1-3 Lord Street, Botany Urban Design Review

Planning Proposal - September 2018

RE: REPONSE TO IDENTIFIED URBAN DESIGN AND HERITAGE ISSUES RELATING TO PLANNING PROPOSAL FOR 1-3 LORD STREET BOTANY

Revised Envelope

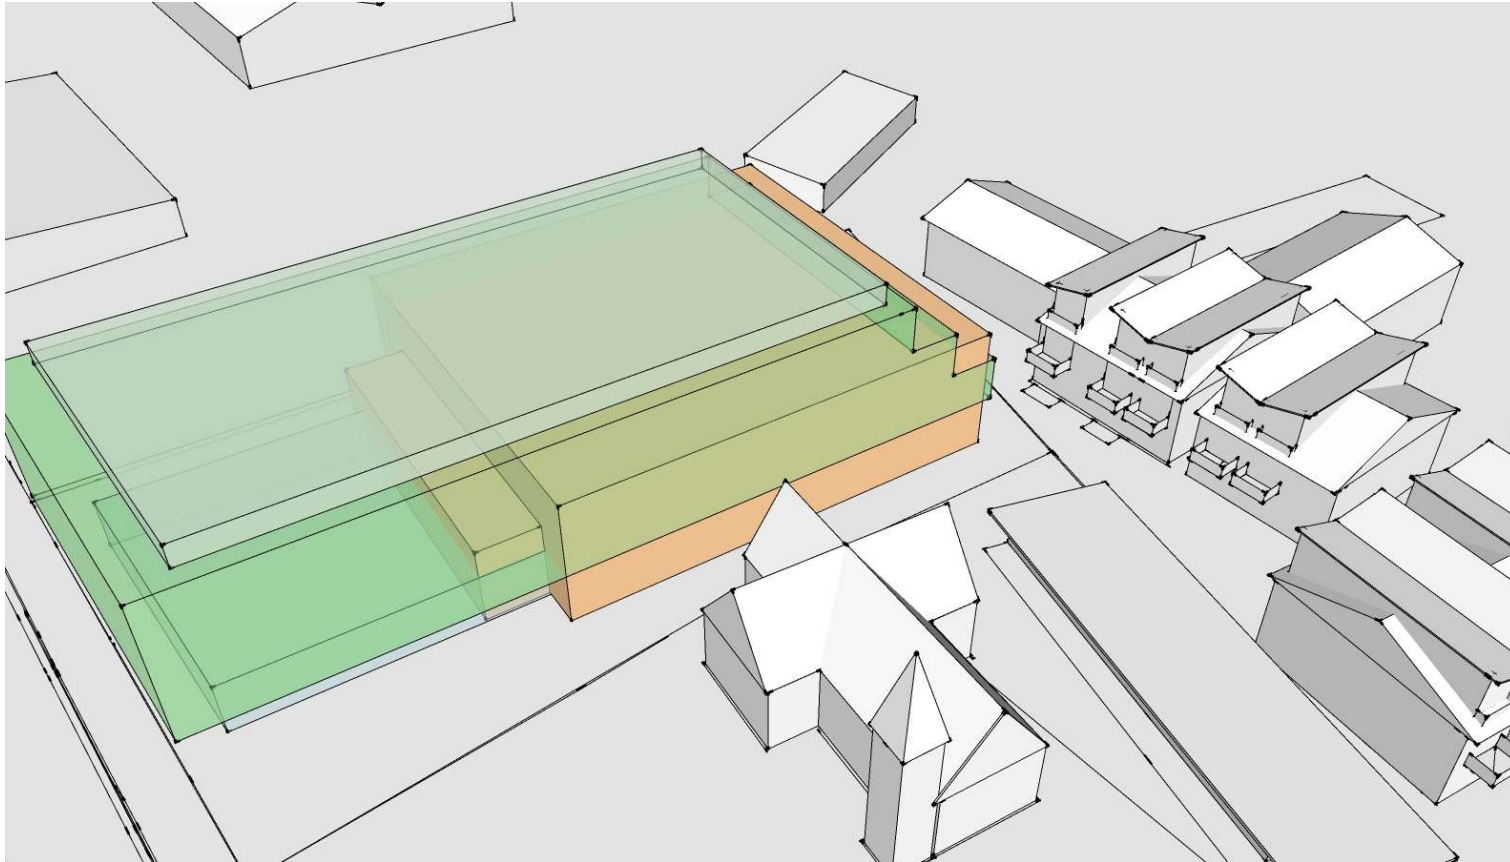
- Revised envelope to address overshadowing of neighbouring residential properties.
- Stepped envelope adopted.
- Envelope depicts the area in which a 1.75:1 FSR will be achieved.
- DCP required and architectural façade and building articulations are not demonstrable.
- Fenestrations and external features may protrude in some areas.

Revised Envelope Setbacks – Upper Floors

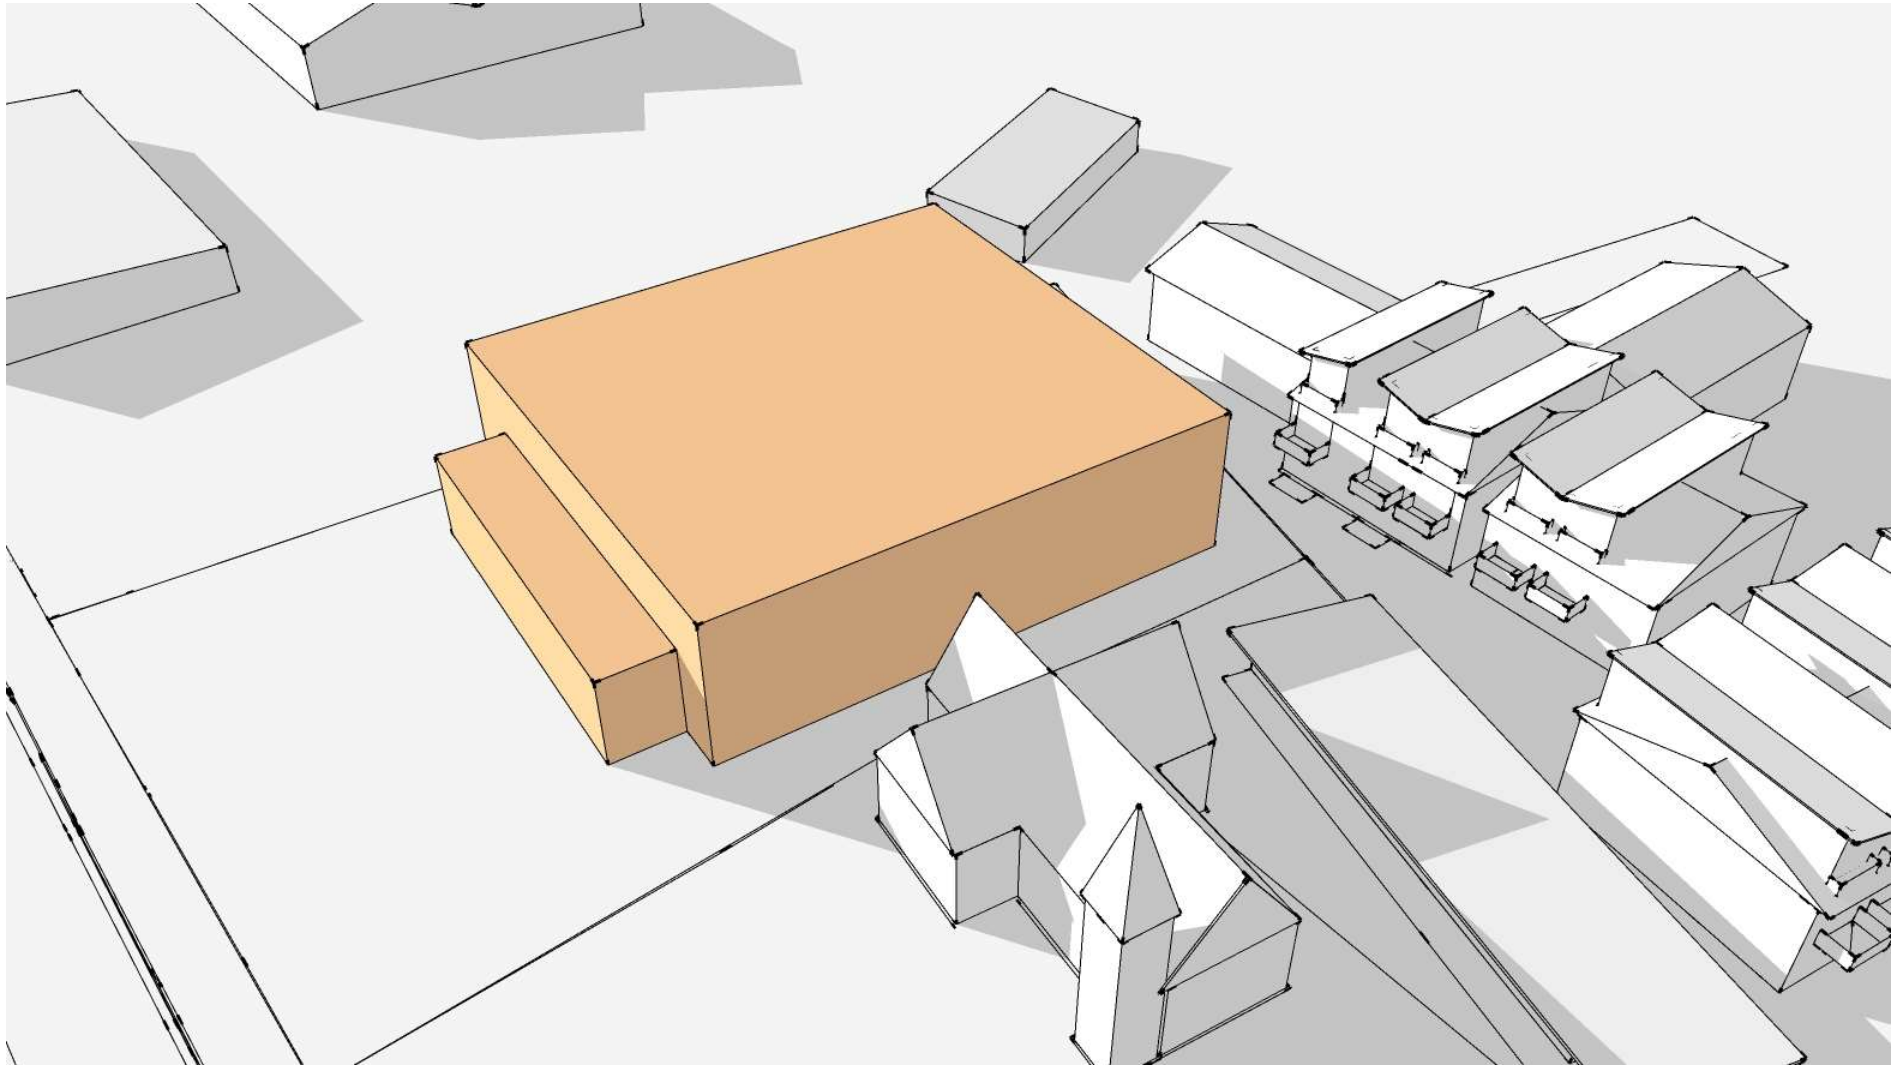
Recommendations by Council's urban designer and heritage consultant seek to increase the proposed setback to the western boundary of the subject site by an additional 3 metres to provide a minimum separation of 9 metres between the church and a future built form on the subject site. It is understood that this is recommendation seeks to minimise perceived impacts in relation to the curtilage of the adjacent heritage item. Previous heritage advice provided to City Plan by Council's heritage consultant in August 2018 also advises that a non-traditional building envelope represented by the indicative overhang may lead to an unsympathetic building form.

- As demonstrated on the 'Revised Envelope Setbacks – Upper Floors' page of the Urban Design Review: the current 6m minimum building to building separation relates to the nave of the church, which extends closest to the subject site, but only has a width of approximately 6m, constituting approximately one third of the Church building's eastern façade. The rear of the nave is not visible from Botany Road and is not significantly visible from Lord Street.

- The church transept constitutes a greater proportion of the Church building's eastern façade (approximately two thirds), and has an aggregate width of approximately 9m. The north-western side of the transept is visible from Botany Rd and is already set back a further 2.9m (approximately) from the boundary to the subject site, which equates to approximately 9 metres of separation distance between a future built form on the site and the majority of the church building.

View from Corner of Botany Rd and Lord St

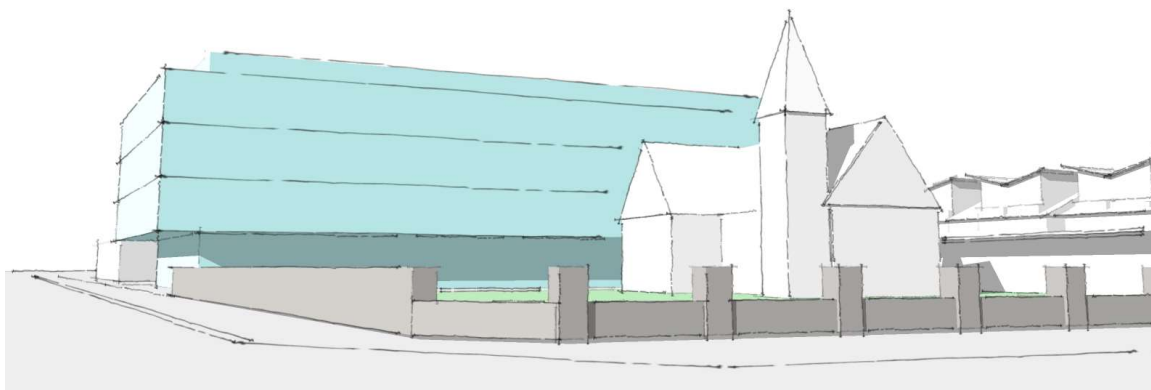
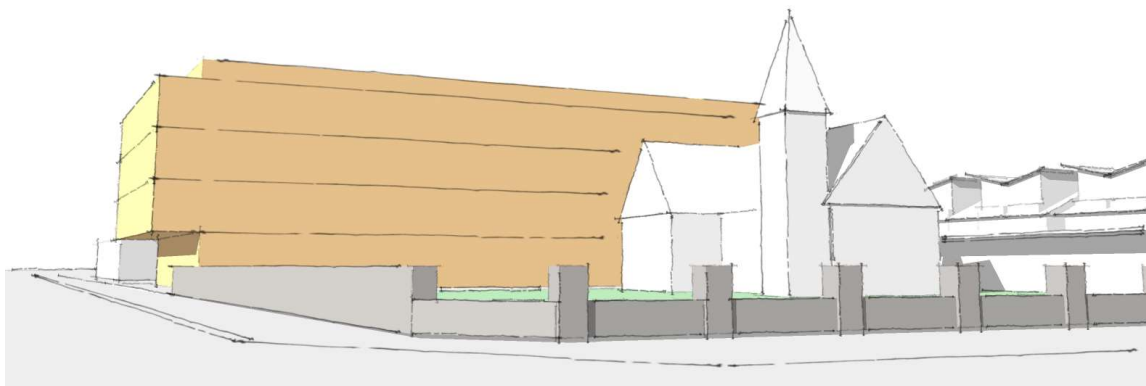
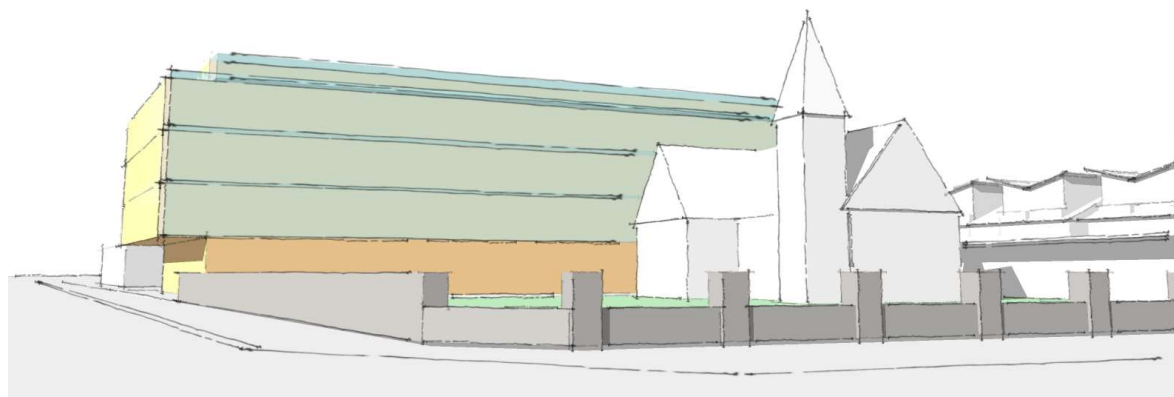
3. Increase the setback to the western boundary of the subject site adjacent to the church by 3m.

Eye level perspective images provided in Attachment A provide a comparison between the proposed setback and the recommended 9m building to building separation. As can be seen from these images:

- increasing the setback to the church boundary by 3 metres will not be visually discernable from the key vantage point at the corner of Botany Road and Lord Street;

- increasing the setback by an additional 3m would not result in any discernable improvement in the visual relationship between the two buildings;
- the view to the church is largely disrupted by trees and a large sign, however it is recognised that these trees are deciduous and the view towards the church is less obstructed in winter months;

- notwithstanding the impact of vegetation on the view towards the church, the church spire would be read above the building on the subject site in either circumstance; and

- with appropriate consideration for building materiality as provided for within the draft site-specific DCP, the diagrams at Attachment A demonstrate that the visual prominence of the church will be maintained, and indeed improved.
